# ARKANSAS POWER & LIGHT COMPANY

SUBJECT: Arkansas Nuclear One - Units 1 & 2  
Docket Nos. 50-313 and 50-368  
License Nos. DPR-51 and NPF-6  
Final Response to NRC's Questions  
on AP&L's Submittal on IE Bulletin  
80-11, "Masonry Wall Design"  
(File: 1510.1, 2-1510.1)

### RESPONSE TO NRC QUESTIONS ON ARKANSAS NUCLEAR ONE - UNIT 1

### RESPONSE TO NRC QUESTIONS ON ARKANSAS NUCLEAR - UNIT 2

FIGURE 1

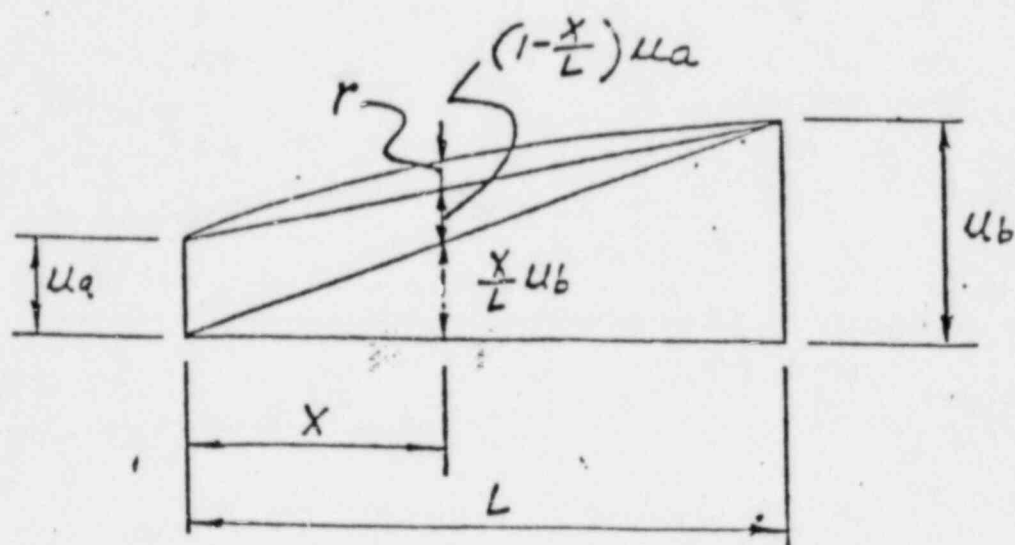
With reference to Section 6.1.4, Appendix A (2), justify using the average acceleration rather than the envelope of the response spectra for walls supported by two floors.

The evaluation herein demonstrates that the use of the average floor acceleration response spectra to calculate the response of the wall panel is appropriate. For the purpose of this evaluation, the seismic response of a simply-supported, uniform beam simulating a strip of the wall panel with unit width is considered, as shown in Figure 1.

FIGURE 3

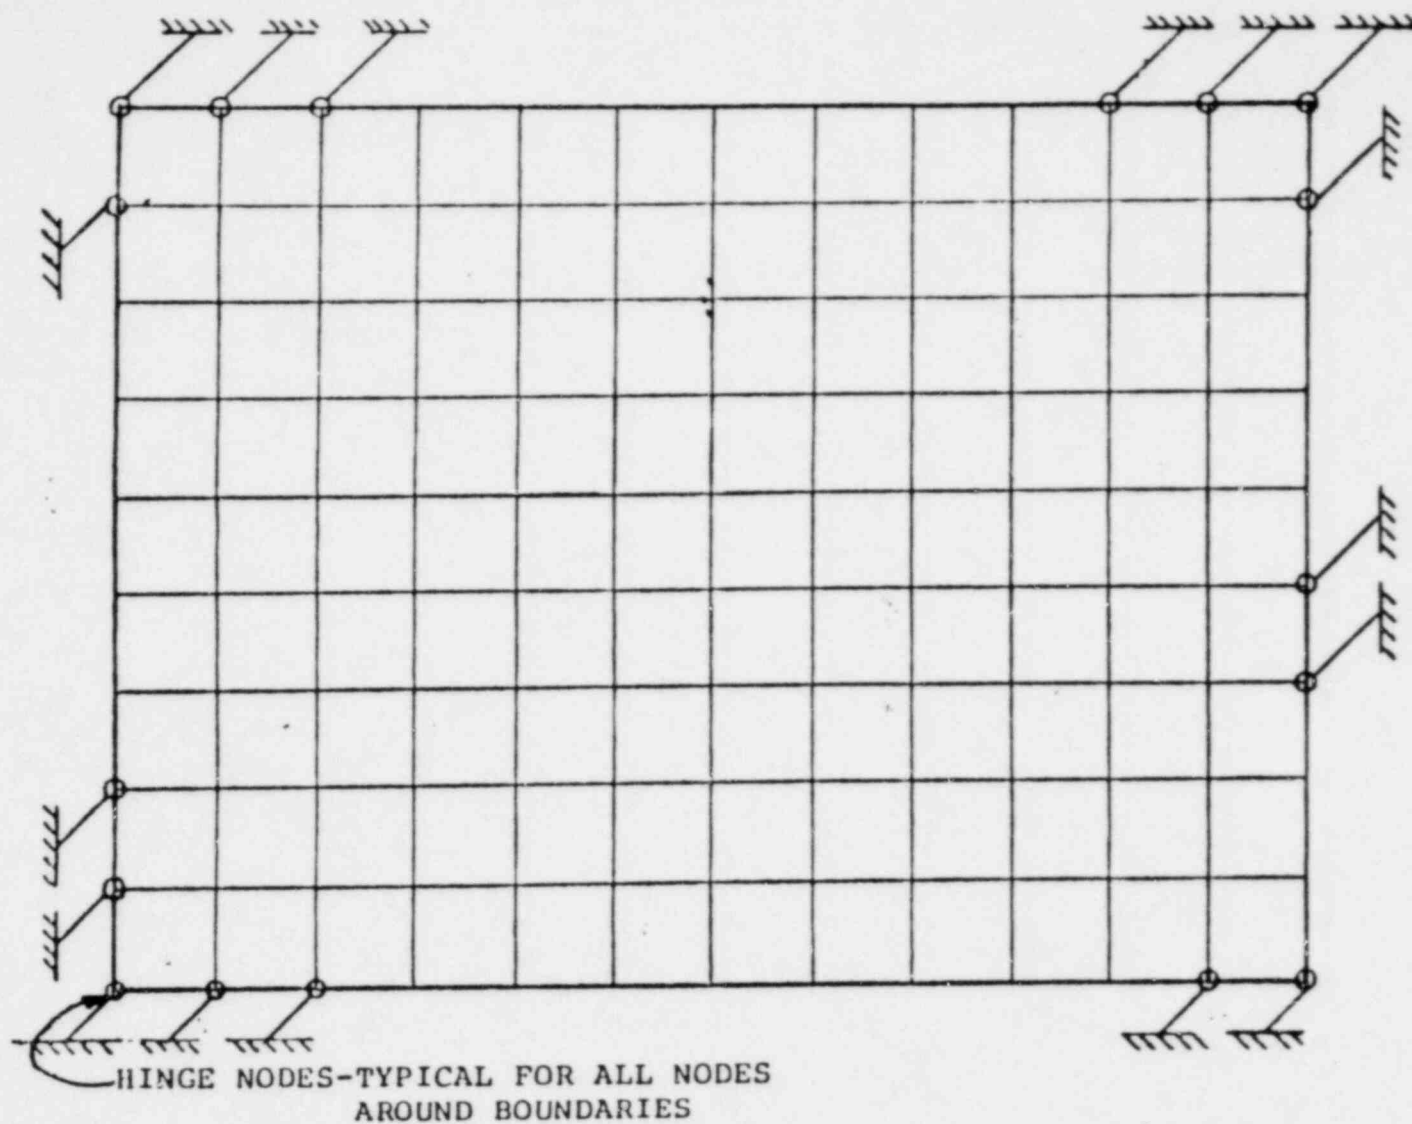
With reference to Section 6.1.2, Appendix A(2), provide sample calculations to show that analysis using only the fundamental mode is adequate and is comparable to a multimode analysis.

The first sample wall is a multiwythe cantilever wall of 1'-6" thick and 8'-0" high. This wall was analyzed as two cantilever beams tied by springs in one-way action. A typical mathematical model is shown in Figure 3. A dynamic analysis as described in the response to Question 5C was performed to obtain moments and shears of the wall due to seismic loads in the out-of-plane direction.

Since the shear strength of mortar and grout at the collar joint was conservatively assumed to be zero for all multiwythe walls for the ANO-1 plant, a non-composite section was considered in the analysis. Two exterior wythes of the wall were modeled as two separate flexural members tied together by tie bars. These tie bars were modeled as springs connected to the lumped masses of each flexural member. A typical mathematical model for the multiwythe cantilever wall is shown in Figure 3.

FIGURE 1

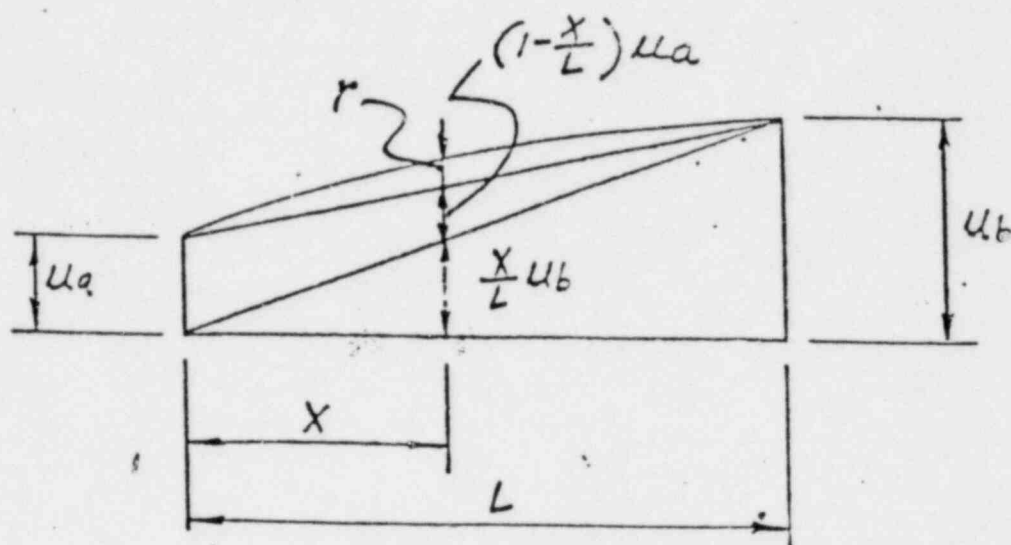
With reference to Section 6.1.4, Appendix A (2), justify using the average acceleration rather than the envelope of the response spectra for walls supported by two floors.

The evaluation herein demonstrates that the use of the average floor acceleration response spectra to calculate the response of the wall panel is appropriate. For the purpose of this evaluation, the seismic response of a simply-supported, uniform beam simulating a strip of the wall panel with unit width is considered, as shown in Figure 1.

FIGURE 3

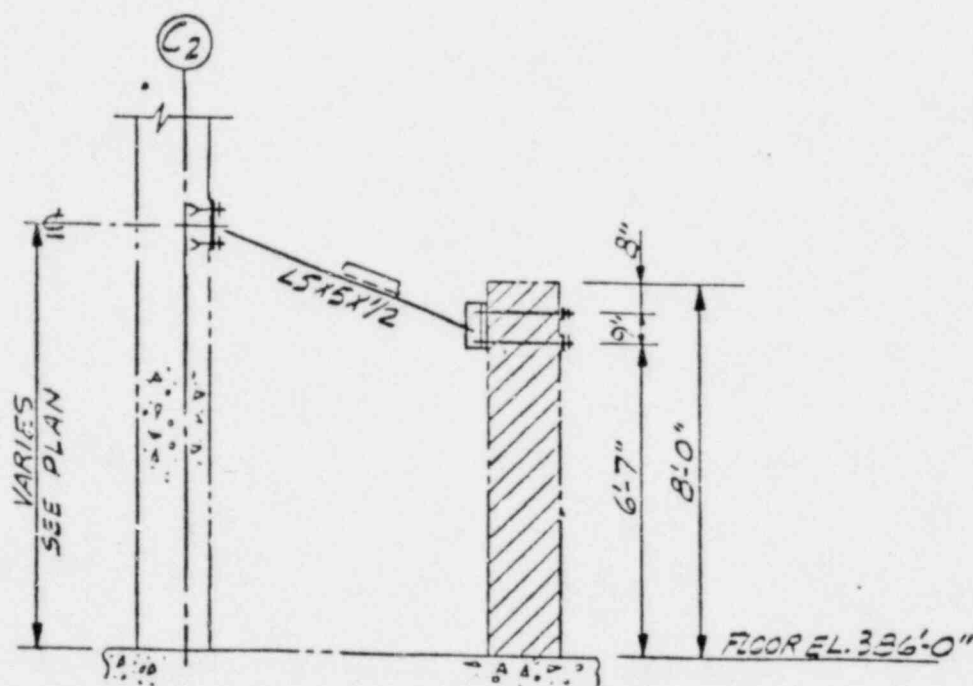
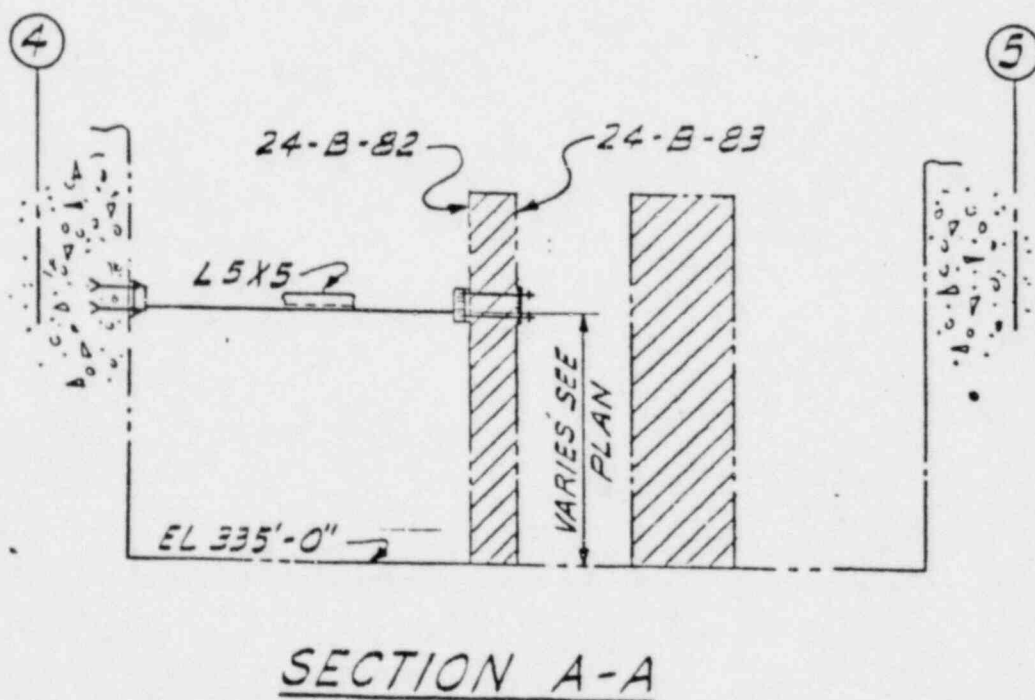
With reference to the cover letter and Table 5 of the attachment (2), provide a description of the bracing system installed for two Unit 2 cantilever walls and indicate whether out-of-plane drift effects were included in the analysis.

The bracing systems installed for two Unit 2 cantilever blockwalls are essentially a set of structural steel angles with steel bearing plates at both ends. These angle members serve as lateral supports to resist the out-of-plane inertia force generated by the cantilever blockwalls during a seismic event. One end of the angle member attaches to the upper portion of the blockwall by means of through-bolts. The other end is supported by an adjacent reinforced concrete wall using concrete expansion anchors. This reinforced concrete wall was evaluated and found to be capable of resisting the additional loads transmitted by the bracing system. Locations and configuration of these bracing systems are shown in Figures 3 and 4.

FIGURE 5

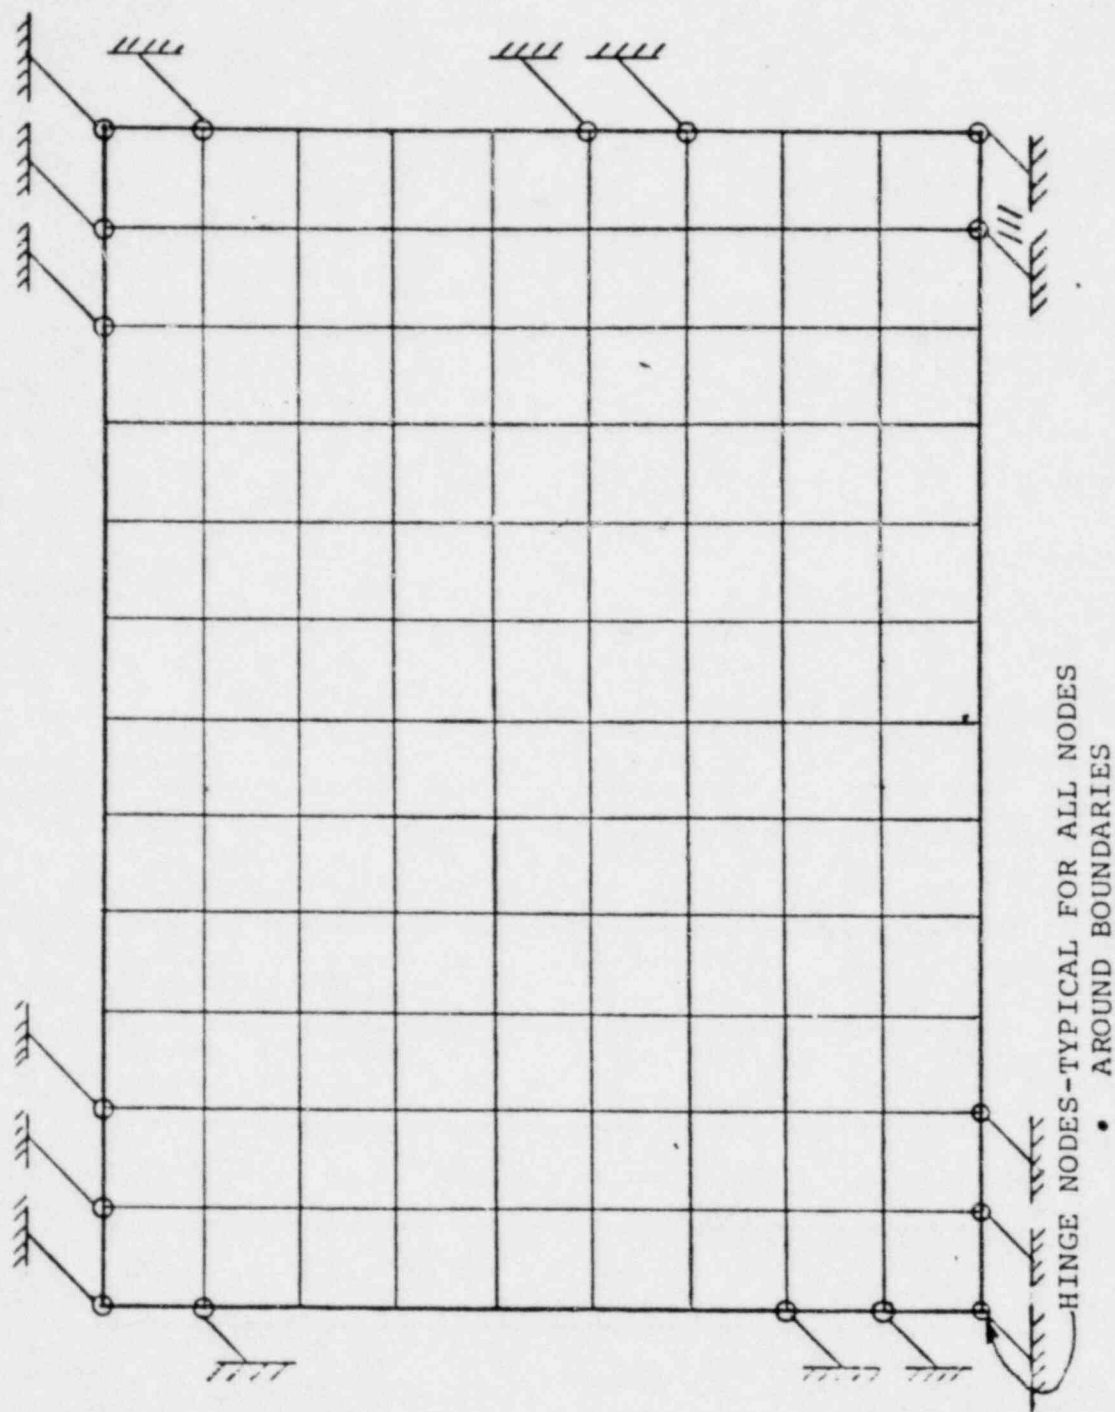
With reference to Section 6.1.2, Appendix(2), provide sample calculations to show that analysis using only the fundamental mode is adequate and is comparable to a multimode analysis.

The first sample wall is a multiwythe cantilever wall of 1'-6" thick and 8'-0" high. This wall was analyzed as two cantilever beams tied by springs in one-way action. A typical mathematical model is shown in Figure 5. A dynamic analysis as described in the response to Question 6c was performed to obtain moments and shears of the wall due to seismic loads in the out-of-plane direction.

These tie bars were modeled as springs connected to the lumped masses of each flexural member. A typical mathematical model for the multiwythe cantilever wall is shown in Figure 5.
